TRANS/WP.29/GRSP/37
24 June 2005

Working Party on Passive Safety (GRSP)

**REPORT OF THE WORKING PARTY ON PASSIVE SAFETY (GRSP)
ON ITS THIRTY-SEVENTH SESSION**

AMENDMENTS TO REGULATION No. 14 ADOPTED BY GRSP AT ITS
THIRTY-SEVENTH SESSION
(see paragraph 10. of this report)

Figure 7: ISOFIX Top tether anchorage location, ISOFIX zone - Enlarged side view of wrap-around area"

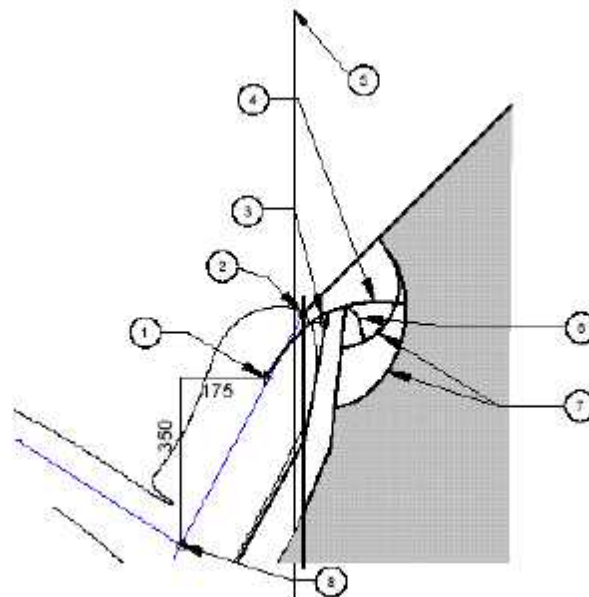
10. Regarding the proposed amendments to figures 6 and 7 of Annex 9 (TRANS/WP.29/GRSP/2005/4, GRSP-34-20, GRSP-36-13, GRSP-37-14), GRSP agreed that figure 6 did not need to be amended and agreed to amend figure 7 as reproduced in Annex 2 to this report. The secretariat was requested to transmit the adopted proposal to WP.29 and AC.1, for consideration at their November 2005 sessions, as draft Corrigendum 3 to the 06 series of amendments to Regulation No. 14.

Annex 9, Figure 7,

For the existing figure substitute
